HAWTHORNE THIRD ADDITION

FINAL PLAT
HAWTHORNE THIRD ADDITION
AN ADDITION TO WICHITA, SEDGWICK COUNTY, KANSAS

RE: SUB 2004-33 -- Final Plat of Hawthorne Third Addition

CASE NUMBER: SUB 2004-33 -- HAWTHORNE THIRD ADDITION

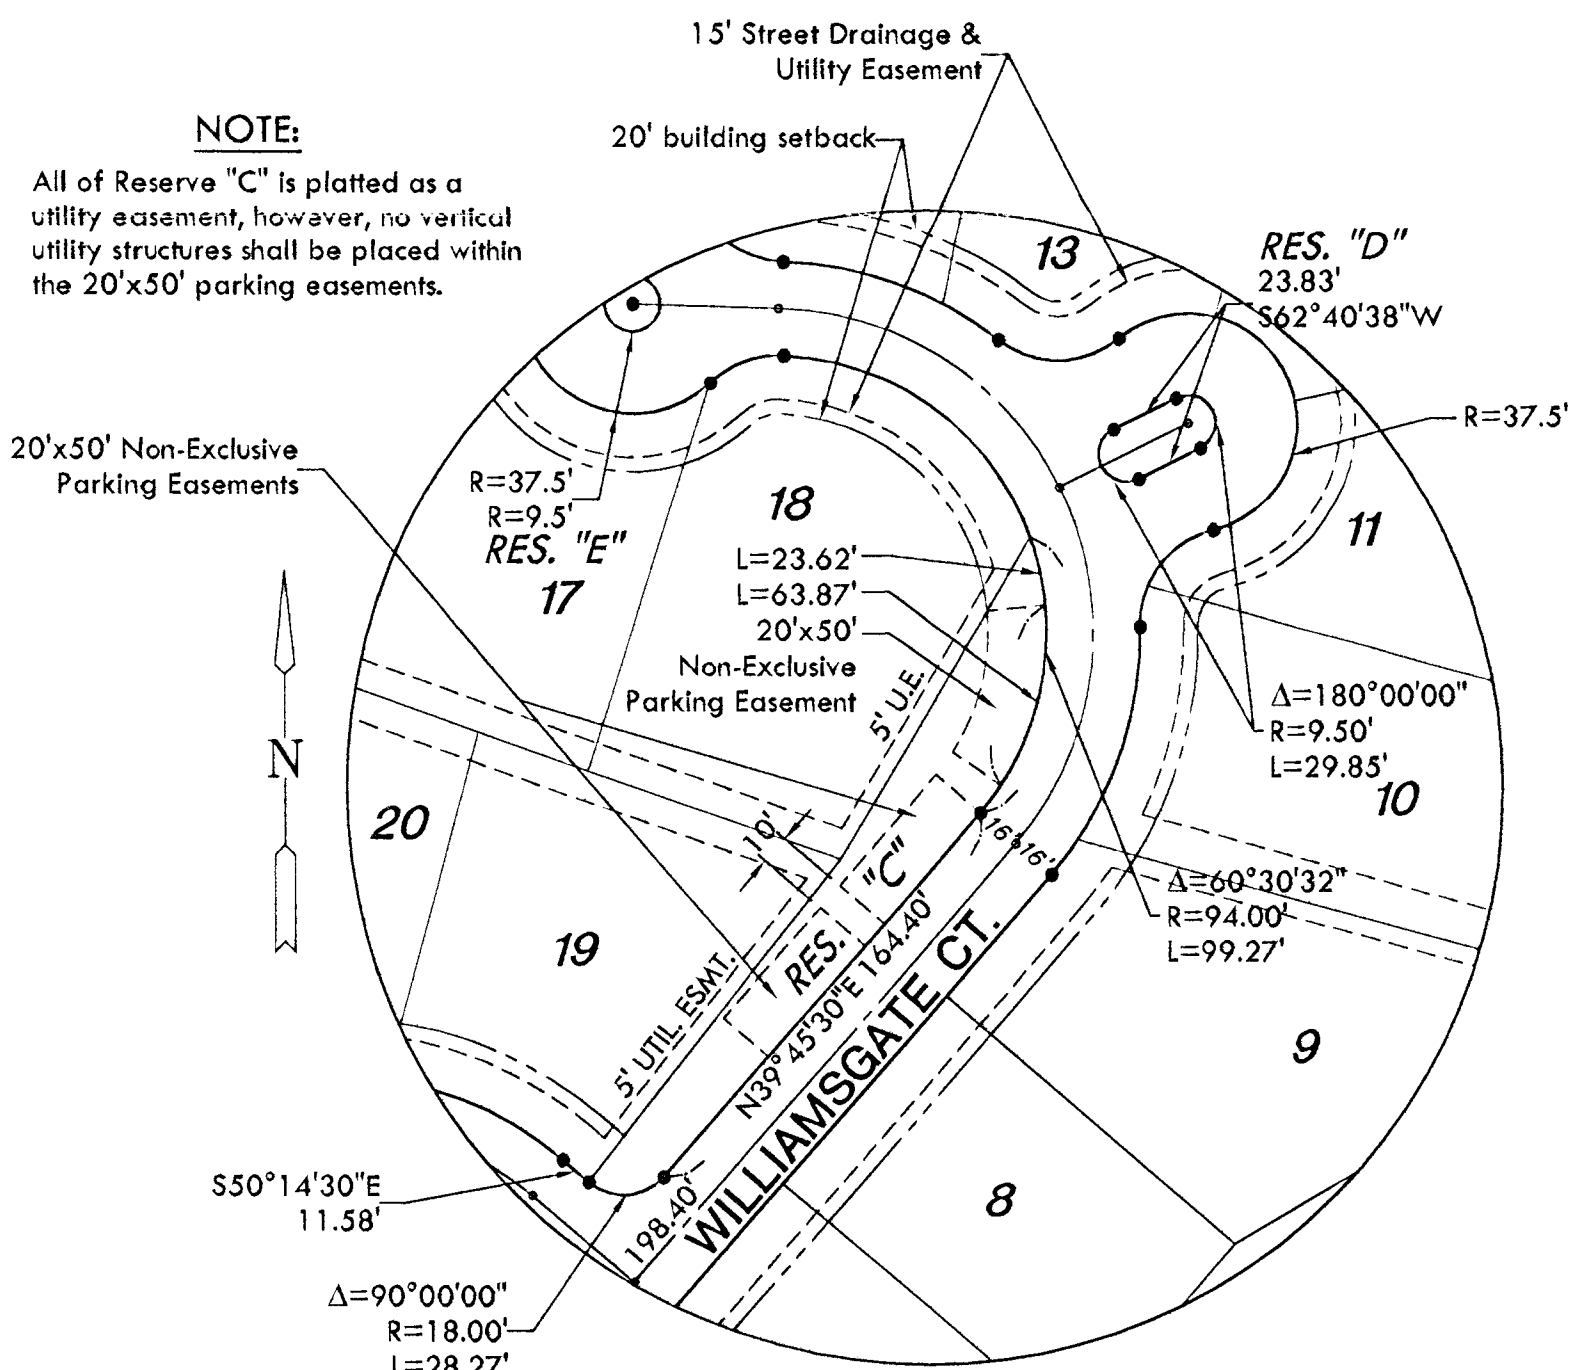
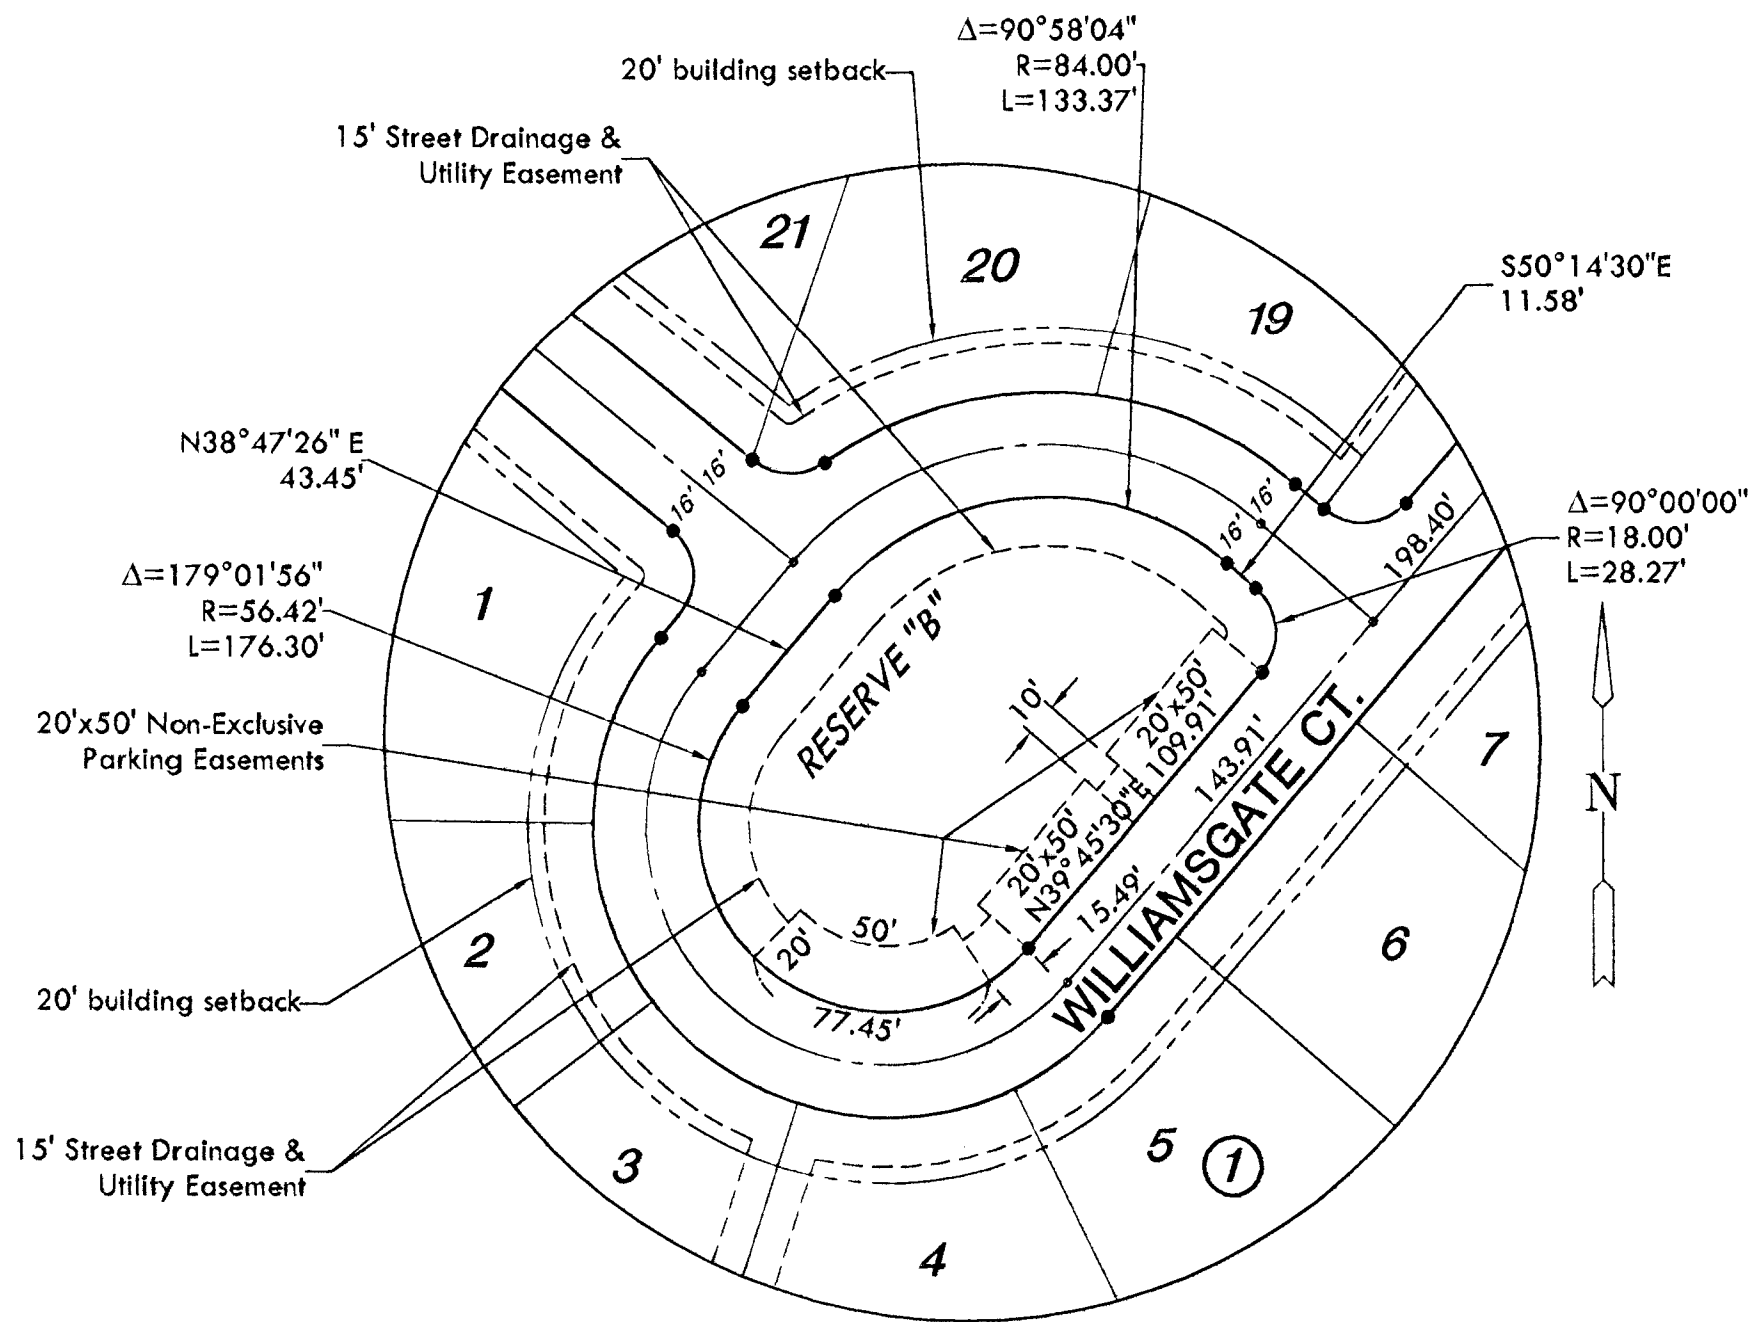
- D. City Engineering needs to comment on the status of the applicant's drainage plan. The drainage plan is approved. A guarantee is required.
- E. The paving guarantee shall also provide for sidewalks on at least one side of all through, non cul-de-sac streets in addition to sidewalks on both sides of Williamsgate which functions as a collector. The applicant has provided an alternate sidewalk plan with one side of the Williamsgate sidewalk located within the reserve. This sidewalk shall be included within the paving petition. The plat's text shall designate the sidewalk in Reserve K for "public access".

- F. The parking easements need to be labeled. Their reference in the plat's text as being "hereby granted to the public" needs to be deleted.
- G. Enlargements of various "Details" indicated on the plat need to be included.

- H. Williamsgate Ct has been platted as a 32-ft narrow local residential street. A 15-ft street drainage and utility easement is needed along the street.

- O. GIS needs to comment on the plat's street names. *The street stub extending to the east - Camden Chase - needs to be labeled.*
- P. The signature line for the City Clerk needs to be revised to reference "Karen Sublett".

- R. The legal description needs to be revised to clarify "Part of Williamsgate, Camden Chase, and Mainsgate".
- S. The platting text shall include language that a drainage plan has been developed for the plat and that all drainage easements, rights-of-way, or reserves shall remain at established grades or as modified with the approval of the applicable City or County Engineer, and unobstructed to allow for the conveyance of stormwater.
